Item No. 9.1.2
Design Review Committee
September 9, 2021

SUBJECT: **Case 23726: Substantive Site Plan Approval – 1470 Queen Street, Halifax**

1. Approve the qualitative elements of the substantive site plan approval application for an 8-storey mixed-use building on lands at 1470 Queen Street, Halifax (PID 00077461), as shown in Attachment A;
2. Approve the variances to the Land Use By-law requirements regarding minimum streetwall width, internal property line setbacks above the streetwall, maximum and minimum streetwall heights and upper storey streetwall stepbacks, as contained in Attachment B;
3. Accept the findings of the quantitative Wind Impact Assessment, as contained in Attachment C; and
4. Recommend that the Development Officer accept the undergrounding of electrical and communication distribution systems (underground vault for utilities) as the post-bonus public benefit category.

2 BUILDING ELEVATION - NORTH FACADE
 A1.16 1/8" = 1'-0"

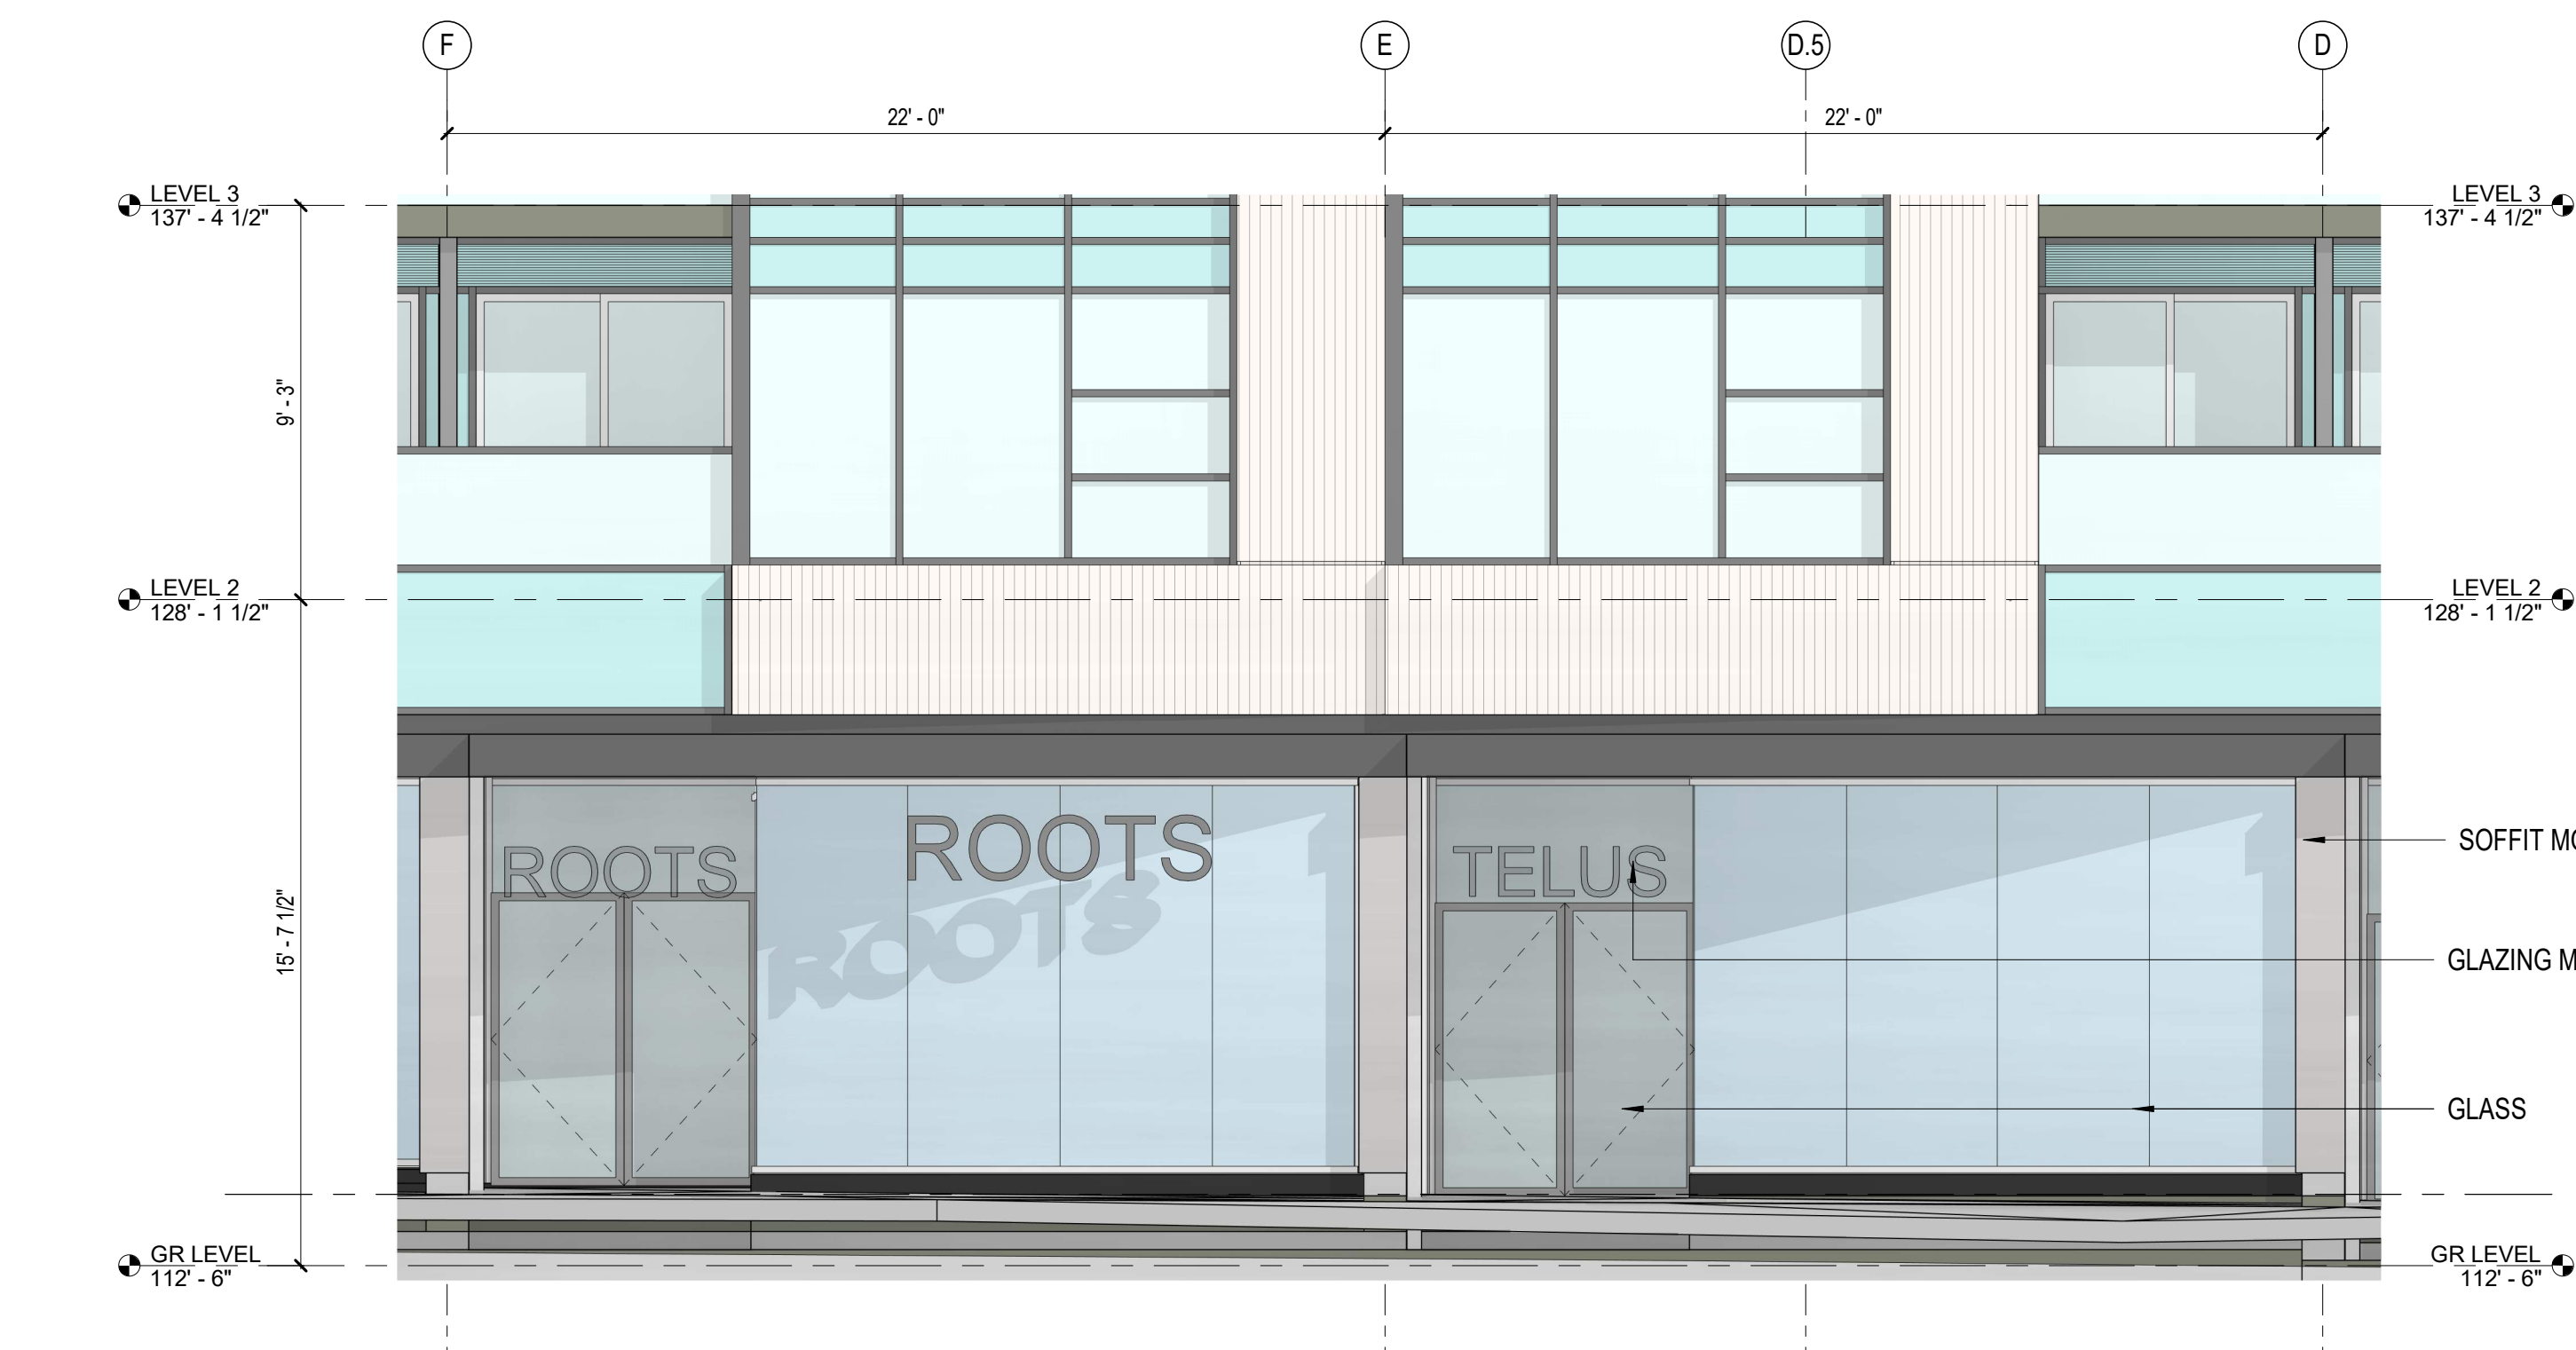
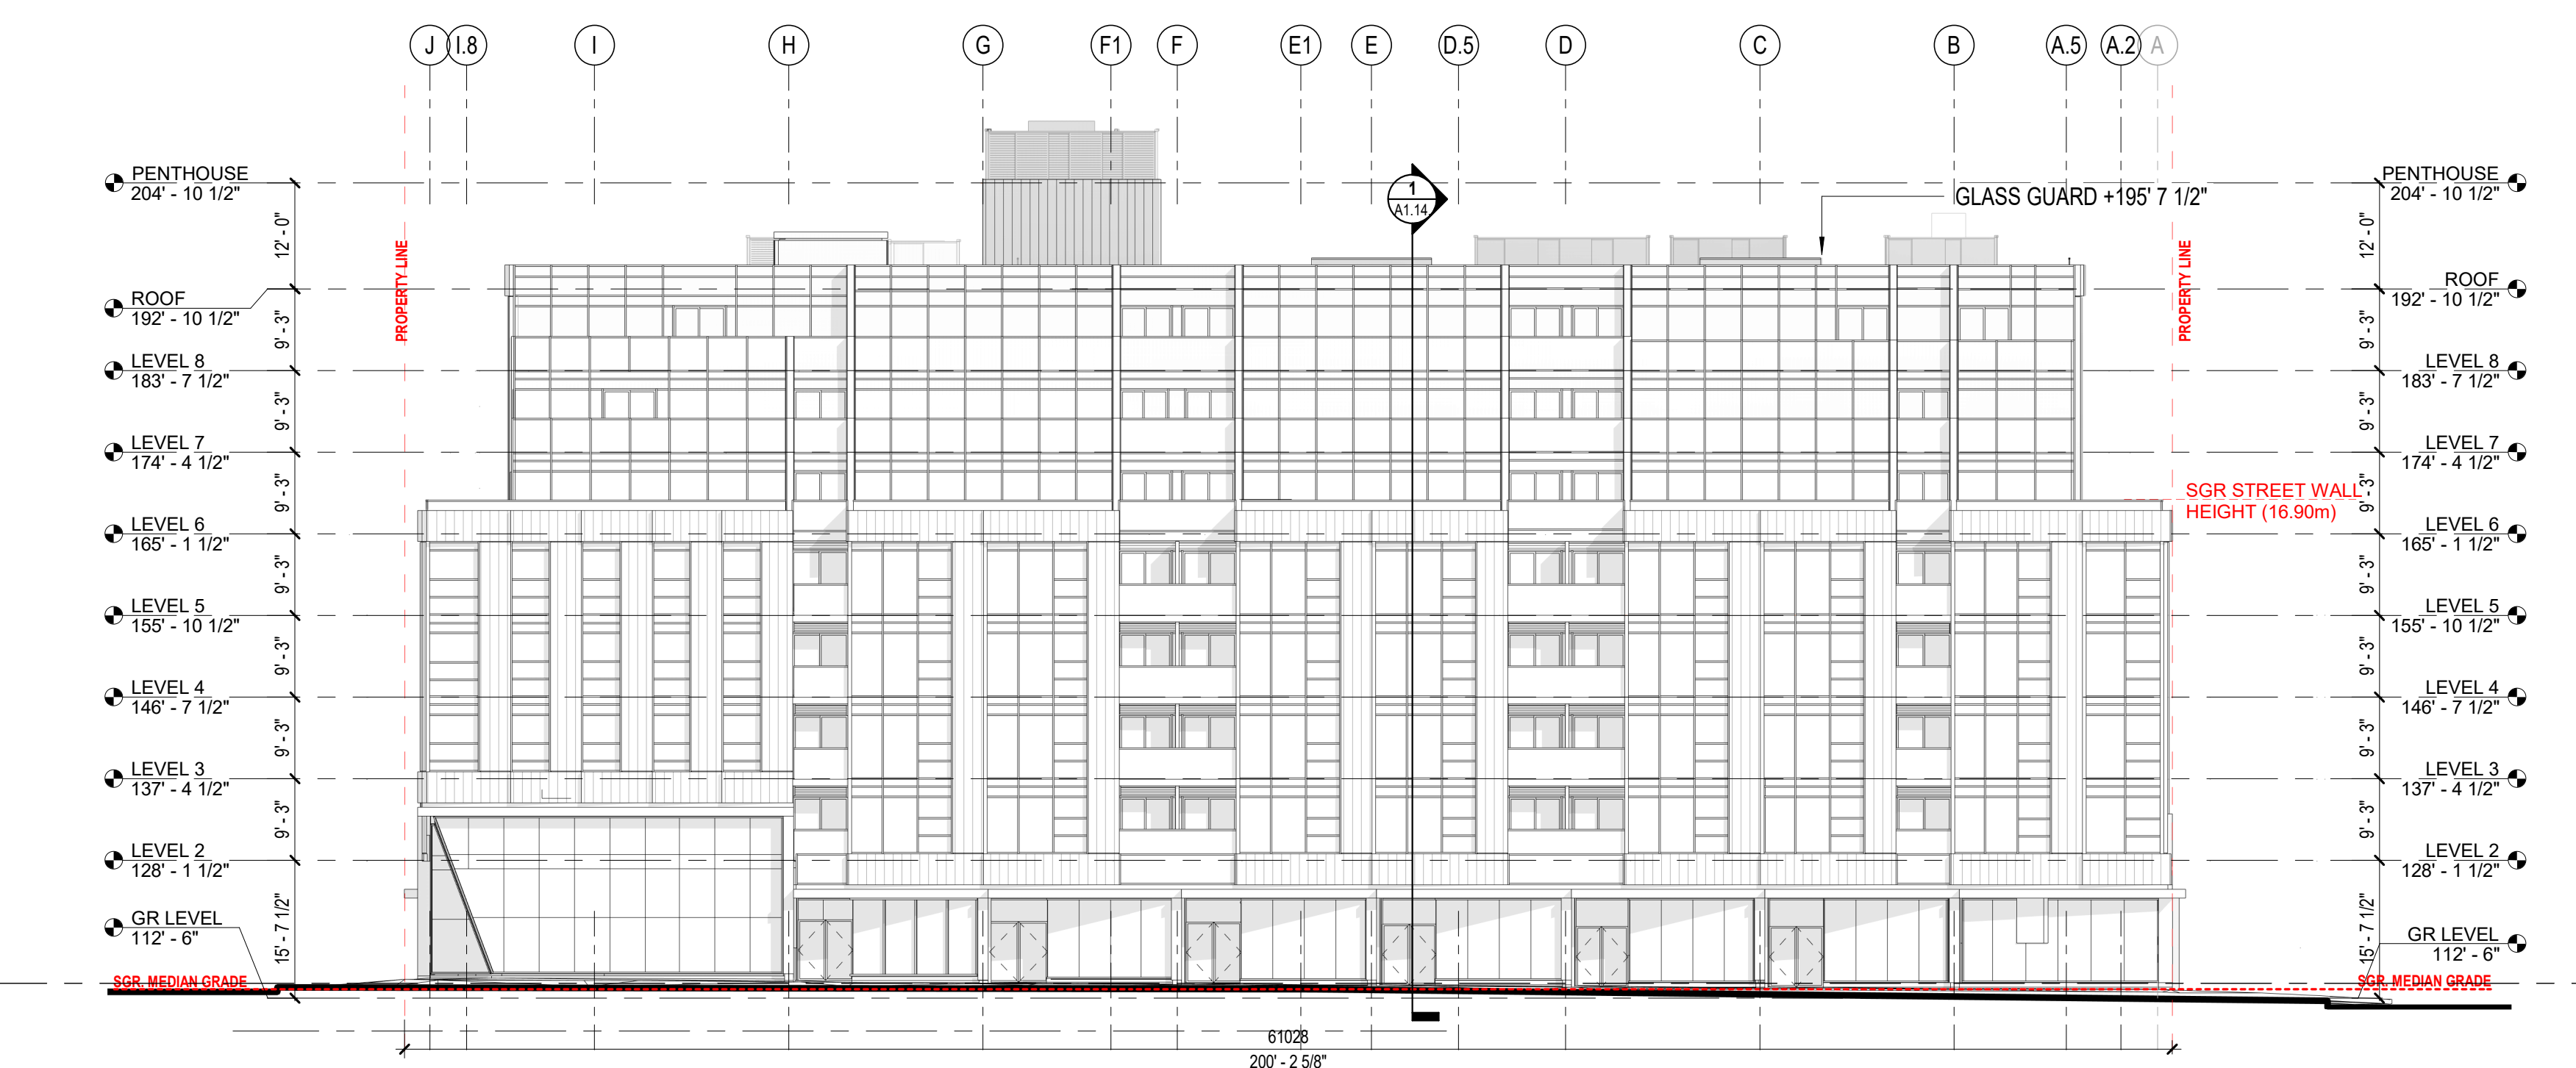
The use of clear glass or glass and metal rails is a reasonable solution in this case. LUB Section 11(3), which requires stepbacks above the 17m streetwall to achieve an angular plane for sunlight penetration onto Spring Garden Road, cannot be varied. Therefore, the use of glass instead of a solid parapet is necessary in order to avoid infringing upon the angular plane. Additionally, as noted in the applicant's submission, the continuous horizontal balconies provide a unifying design feature that complements the vertical breaks in the Spring Garden (north) facade and ties the design together into a cohesive whole, resulting in a positive benefit. Staff recommend approval of this variance.

BUILDING ELEVATION - WEST

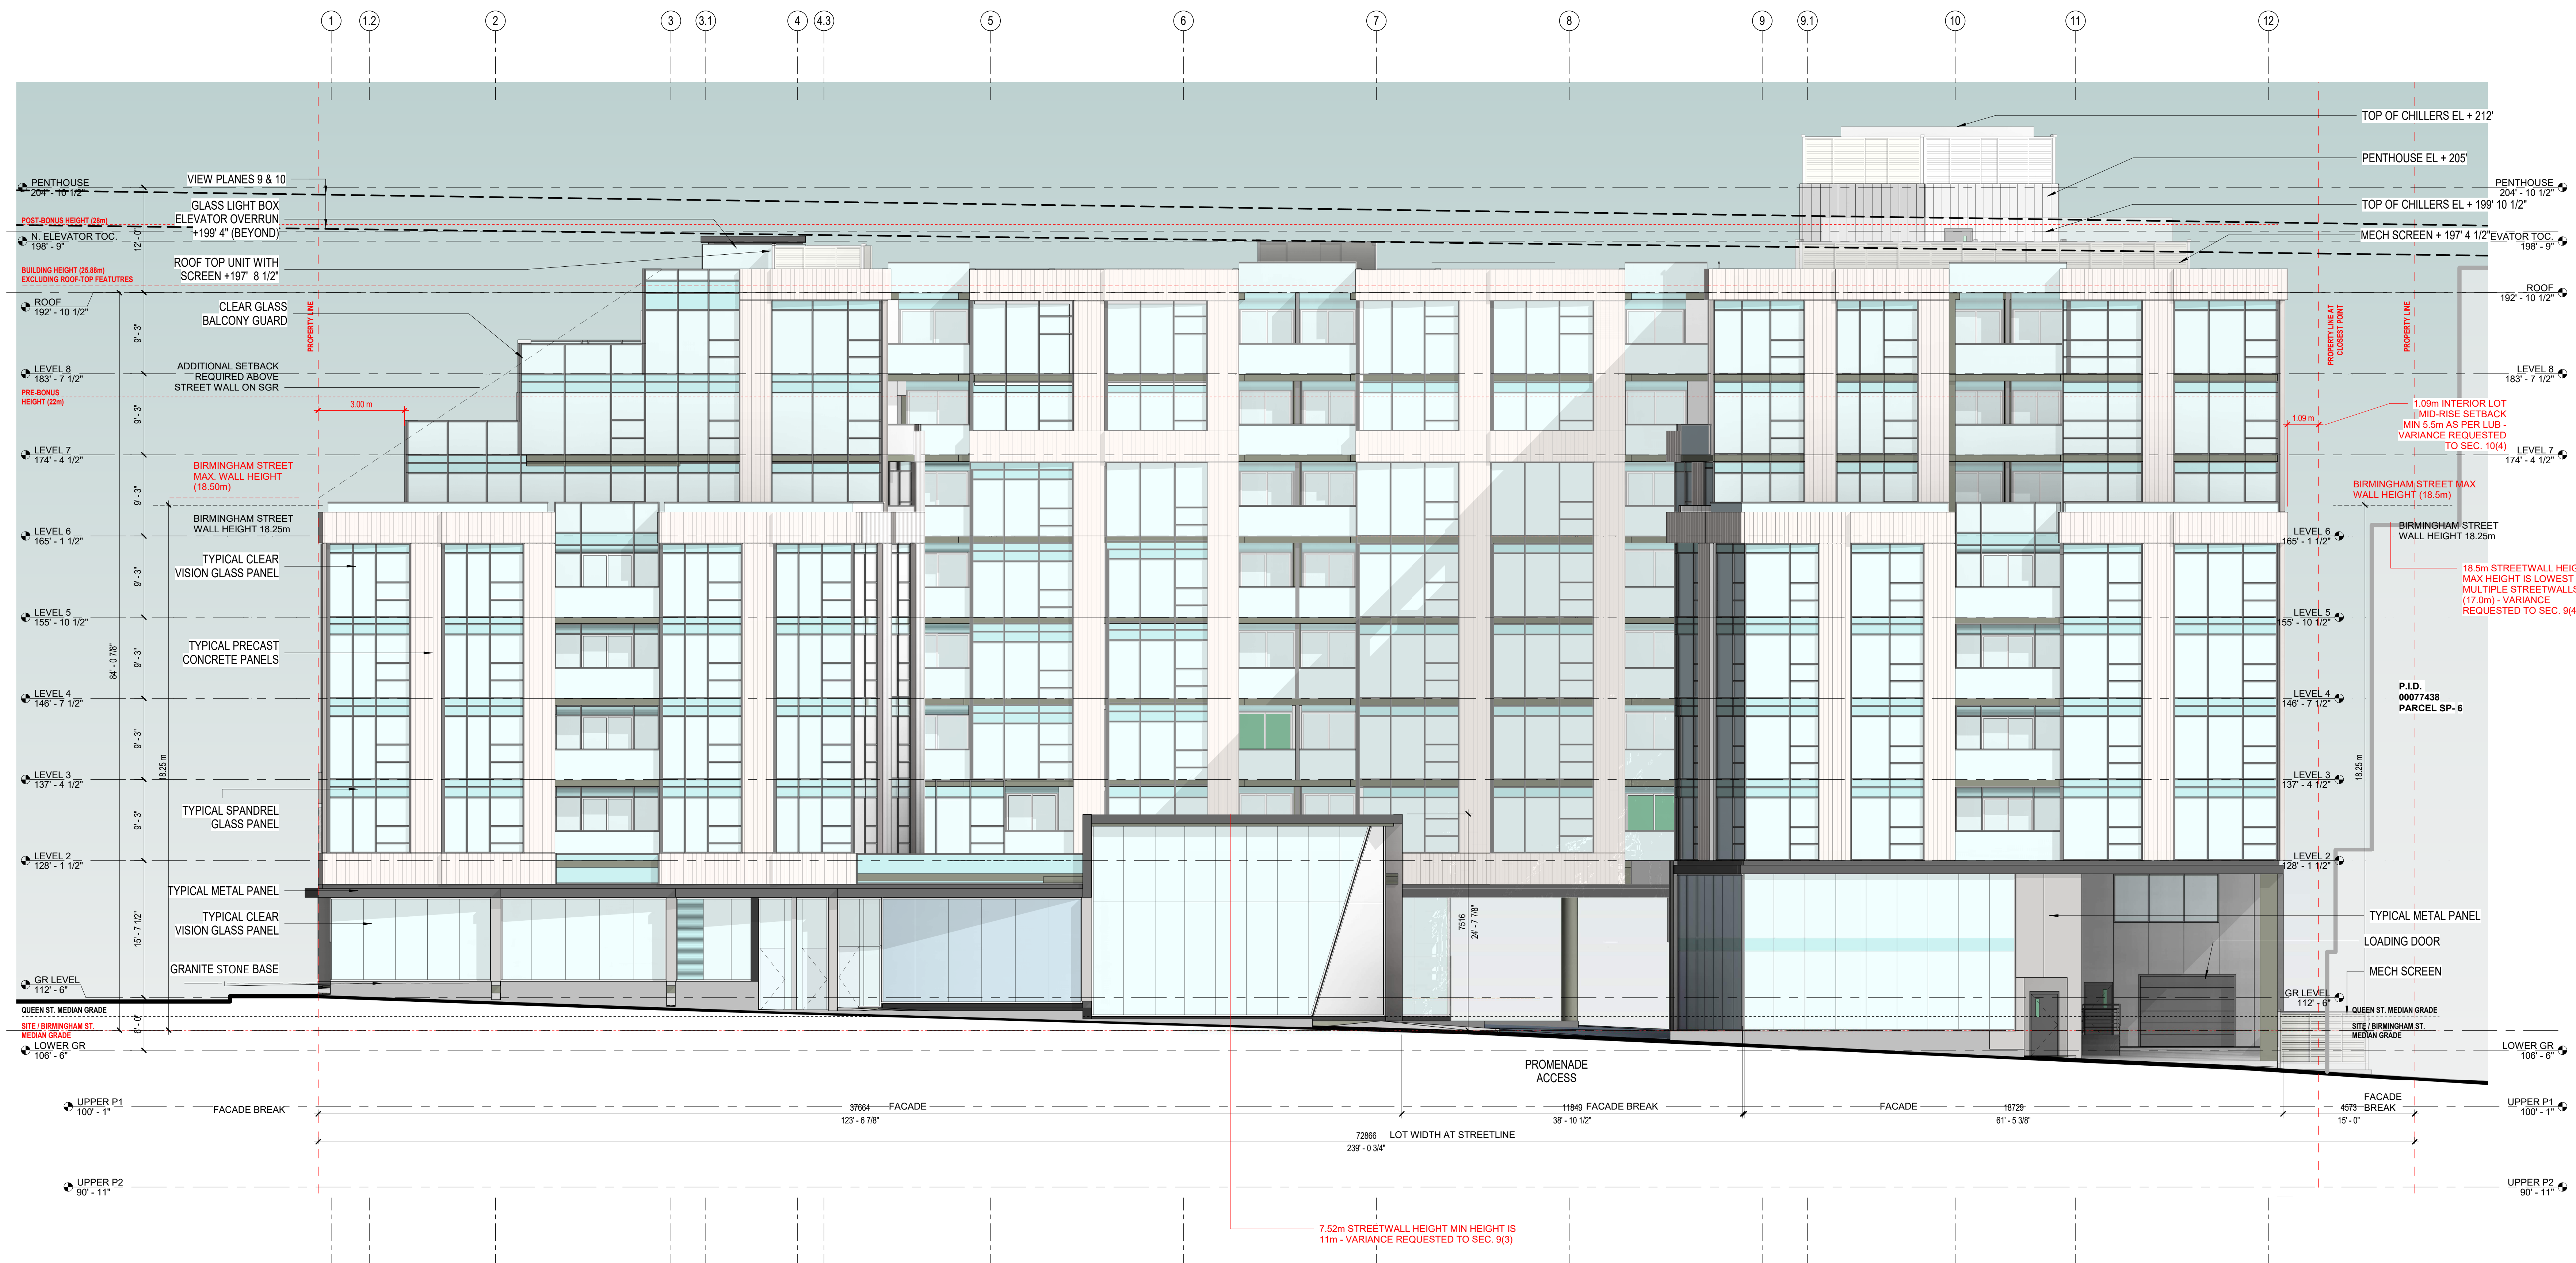
be seen on the west elevation drawing. Section 9(8) of the LUB allows consideration of a variance where the relaxation is consistent with the criteria of the Design Manual.

Section 9(3) of the LUB requires that the minimum streetwall height shall be 11 metres high. The applicant has requested a variance to this requirement on Birmingham Street to allow for the portion of the streetwall that abuts the pedestrian promenade entrance, with one level of commercial space and landscaped rooftop area above for tenants. This condition can be most easily seen on the west elevation drawing.

The proposed reduction in the minimum streetwall height in this case is reasonable. The commercial restaurant corner element of the streetwall will be maintained and will provide a human scale and pedestrian-friendly aspect to the promenade, with more sunlight penetration into the space than with a larger streetwall in this location. Therefore, staff recommend approval of this variance.
